CHANGE ORDER APPROVAL FORM

PROJECT: US 1 @ Ratliff Road
Intersection Improvements Project

CHANGE ORDER NUMBER: 05
DATE: 01/27/11
CONTRACT NUMBER: CM1606

Reason for Change Order: Remove and replace previously installed 18" MES at Sta. 20+82 at new offset. Location change required due to requirement to provide a 4:1 slope within the US-1 recovery area per FDOT.

MES @ STA. 20+82.94
 57, 58' LT.

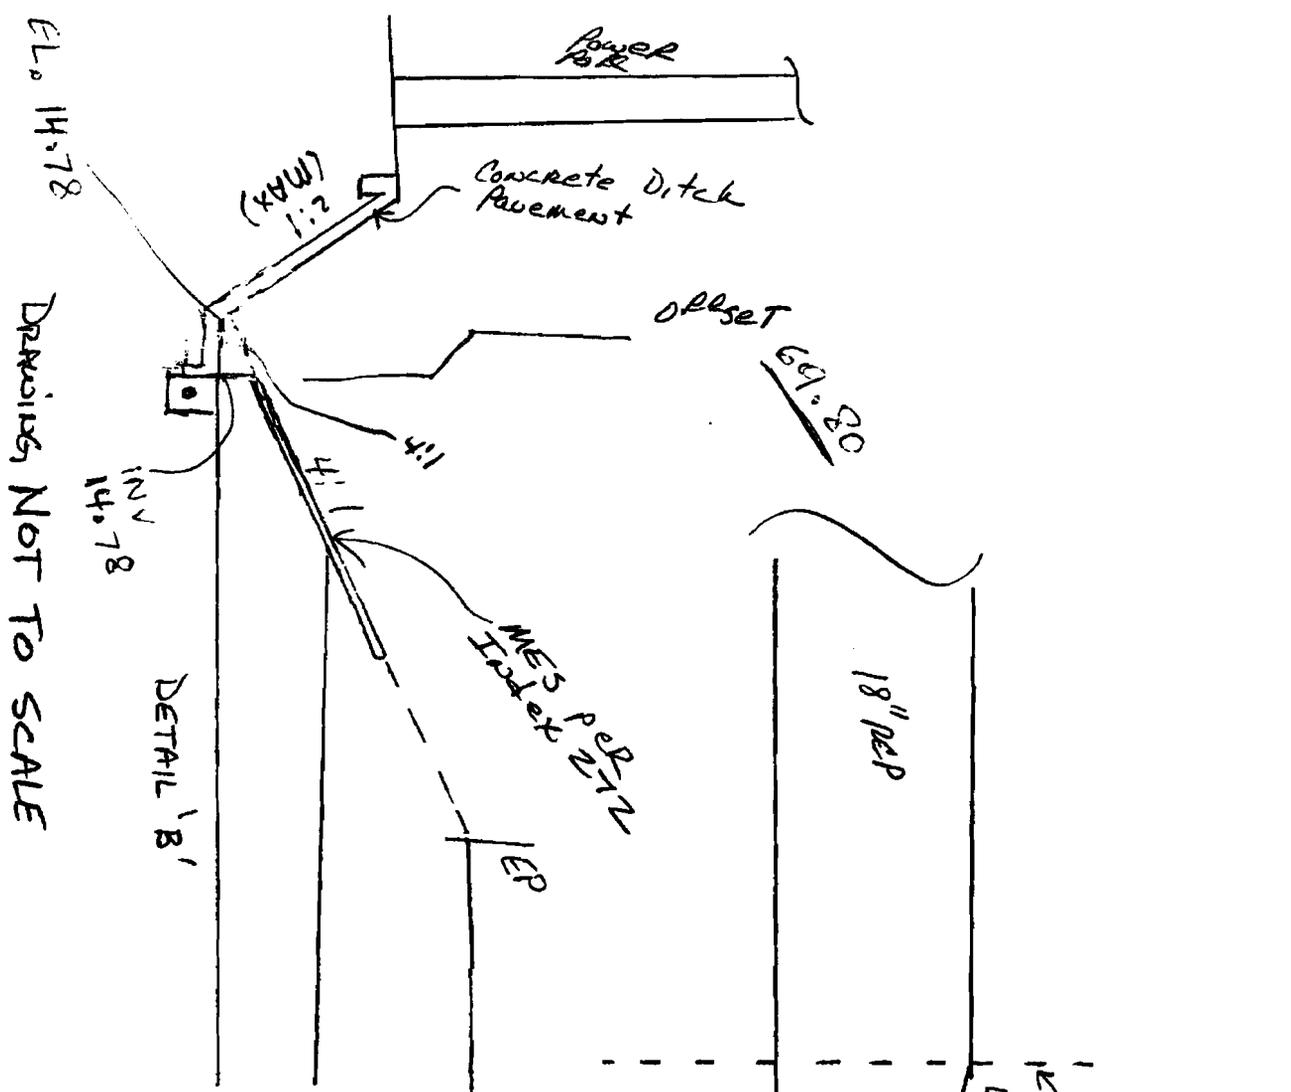
Attached is the detail for the MES issue on the above referenced project. Please review and provide any comments as necessary.

- DETAIL 'A'
- 4:1
- SNAP ON HIDE
 APPROP 2 1/4" of 18" CONCRETE COLLAR
- ① SNOW CUT PREVIOUSLY INSTALLED MES @ TOP OF BEND AS SHOWN IN DETAIL 'A'
 - ② INSTALL 3'-4' OF 18" RCP w/ CONCRETE COLLAR.
 - ③ INSTALL NEW 18" MES SO THAT THE END OF THE MES IS LOCATED AT OFFSET 69.80
 - ④ CONSTRUCT DITCH PAVEMENT FOR BACK SLOPE PROTECTION 3' ON EITHER SIDE OF EXISTING POWER POLE. DITCH PAVEMENT TURNS DOWN ARE TO BE 18" IN DEPTH & 6" WIDE MINIMUM.

All of your instructions are good, but please see attached with slight modifications. The shown offset in the plans is close to the location of the existing headwall. The correct offset in your detail works out to be 69.80 LT at 4:1 slope. Also, the 4:1 slope is extended to the bottom of the ditch (shown dotted), which leads to a steeper back slope to the concrete ditch...
Let me know if you have any questions.

MES @ STA. 20+82.94
69.80 FT.

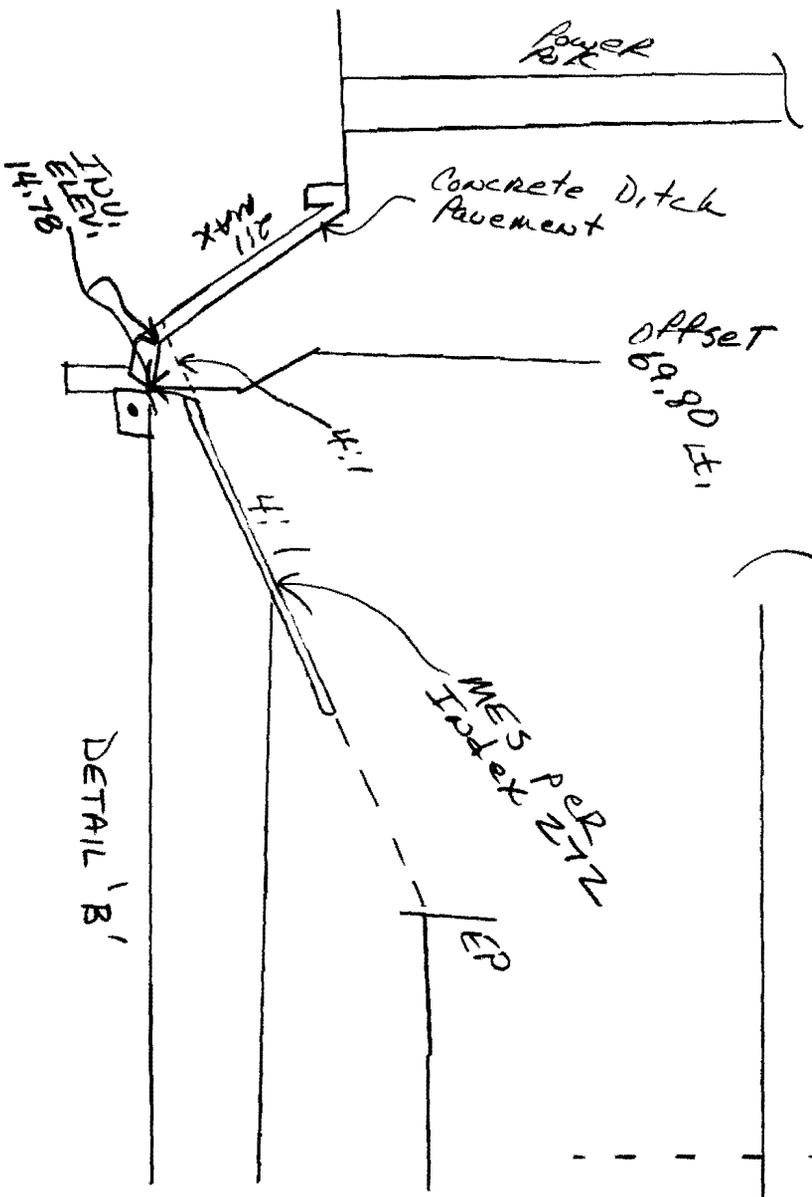
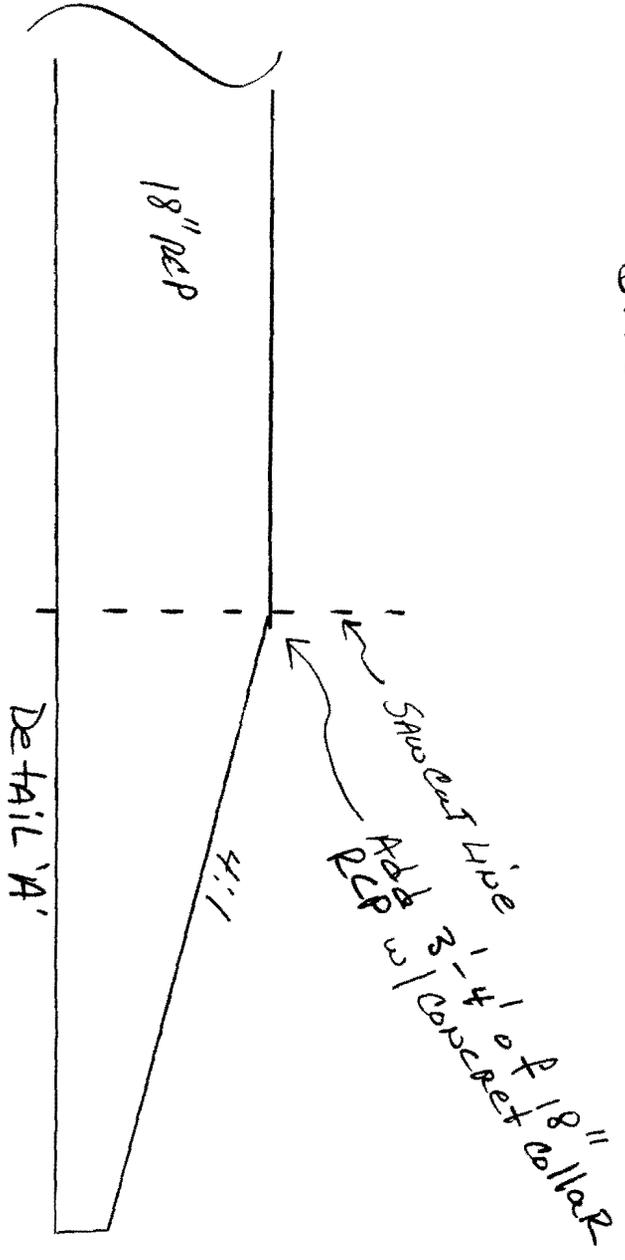
Please provide a cost proposal to perform all work associated with the attached detail for the relocation of the MES at Sta. 20+82.94.

- ① SNAW CUT previously installed MES @ Top of Bevel AS shown IN DETAIL 'A'
- ② INSTALL 3'-4' of 18" RCP w/ CONCRETE COLLAR.
- ③ INSTALL near 18" MES so That The end of The Offset MES IS located at offset 69.80 FT.
- ④ Construct Ditch pavement for Back slope protection 3' on either side of Existing Power Pole. Ditch pavement Turns downs ARE to be 18" in Depth & 6" wide minimum.

STA. 20+82
 CONST. 18" MES
 FL 14.78
 FDOT INDEX 272

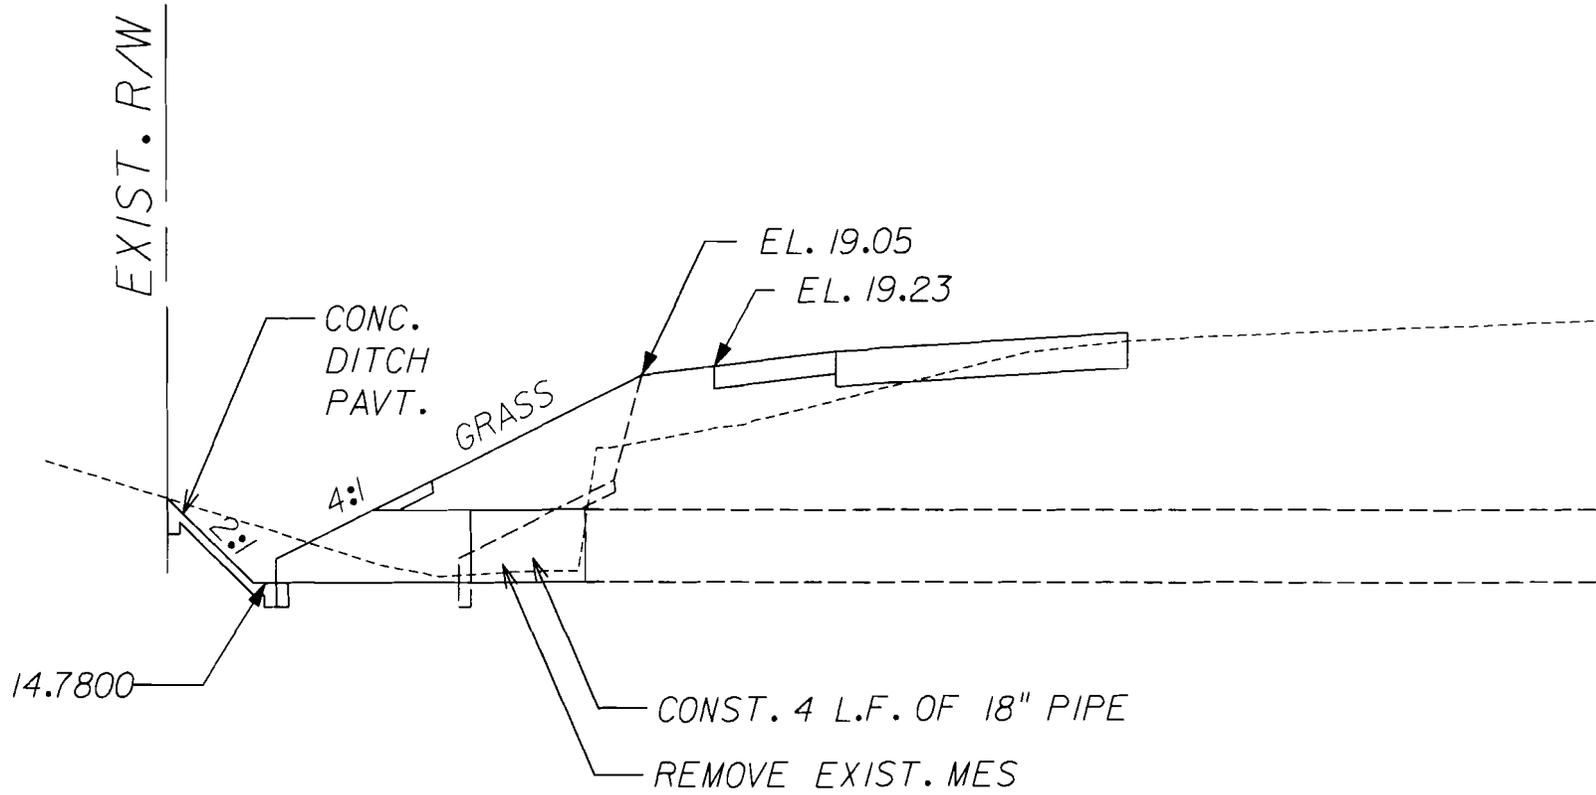
Attached is the detail I promised you weeks ago for the Ratliff Cross drain....no difference really from what they already have in sketch form.

CONC.
DITCH
PAVT.

CONST. 4 L.F. OF 18" PIPE

REMOVE EXIST. MES

Please use the attached in conjunction with the detail previously provided to re-construct the MES at Sta. 20+82 +/- on the above referenced project.
